UNITED STATES PATENT AND TRADEMARK OFFICE

APPLICATION NO.	FILING DATE	FIRST NAMED INVENTOR	ATTORNEY DOCKET NO.	CONFIRMATION NO.
10/559,918	12/07/2005	Marko Leinonen	915-007.172	9575

DETAILED ACTION

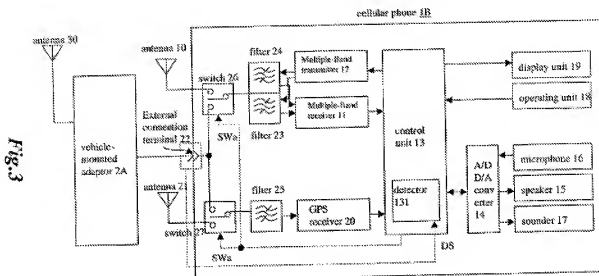
Regarding claims 1, 6, 8-9, 13, 15-19, Yoshida discloses a mobile device with built-in GPS receiver with receiver comprising first and second receiving chain and frequency band; at least a first antenna (shown 2, article 10, 21 in FIG. 3 below) connected to first receiving chain (**cellular** part) switchable (via switcher 26, 27) to second receiving chain (**GPS** section); inherently a tuning portion for shifting frequency response from first frequency band to second band (multiband receiver 11 is capable of

tuning between bands, filter 23-25 also tunes the frequencies) and a controlling portion (control unit).

Regarding claims 3, 10, 20, Yoshida discloses the use of second antenna (antenna 21 in FIG. 3 above) for second frequency band.
